Public Input No. 197-NFPA 99-2015 [Global Input]

Replace all bulk system definitions found in section 3.3.19 and resident to NFPA 99 with system definitions from section 3.3.93 of NFPA 55 (2016 edition). Add extract tag to definitions taken from NFPA 55.

Figure 10.3.6.2 Test Circuit for Measuring Leakage Current Between Patient Leads and Ground — Nonisolated.

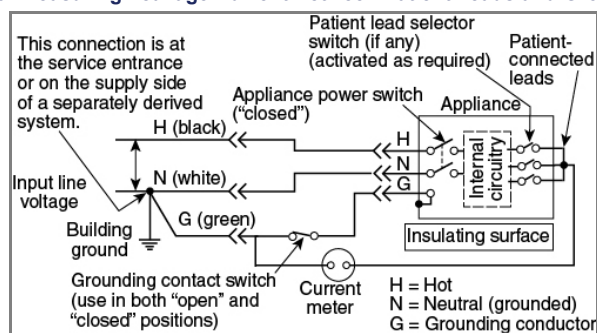
In figure 10.3.6.2, delete the switch in series with the grounding conductor and the label that reads "Grounding contact switch (use in both "open" and "closed" positions)"

Figure A.5.1.3.5.15 Emergency Oxygen Supply Connection.

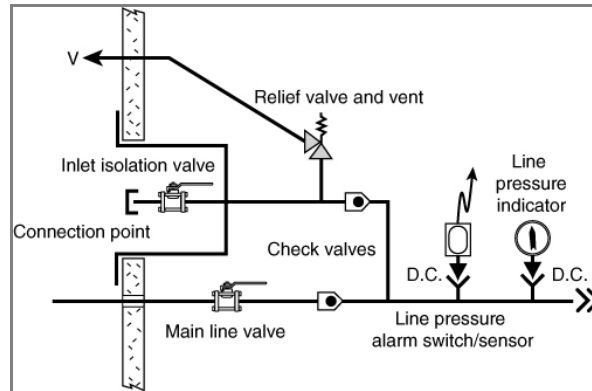
If the relief valve on the emergency oxygen supply connection is moved downstream from the check valve in the emergency oxygen line, it should be connected to the system with a demand check fitting.

The emergency oxygen supply connection (EOSC) can be used as a part of the emergency operation plan (EOP) for an unplanned loss of oxygen supply. However, a risk assessment should be conducted by the facility to determine the contingency plan for vital life support and ~~critical care areas~~ [Category 1 space](#). There might need to be interim measures for dealing with the loss of oxygen (e.g., high-pressure oxygen cylinders available for back feeding ~~critical care areas~~ [Category 1 space](#)).

Statement of Problem and Substantiation for Public Input

Figure A.5.1.3.5.15 Emergency Oxygen Supply Connection.

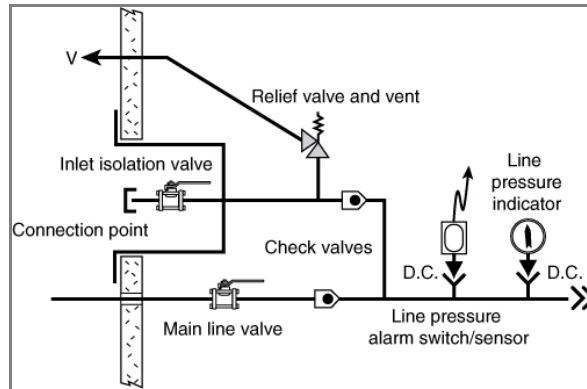
If the relief valve on the emergency oxygen supply connection is moved downstream from the check valve in the emergency oxygen line, it should be connected to the system with a demand check fitting.

The emergency oxygen supply connection (EOSC) can be used as a part of the emergency operation plan (EOP) for an unplanned loss of oxygen supply. However, a risk assessment should be conducted by the facility to determine the contingency plan for vital life support and critical care areas. There might need to be interim measures for dealing with the loss of oxygen (e.g., high-pressure oxygen cylinders available for back feeding critical care areas).
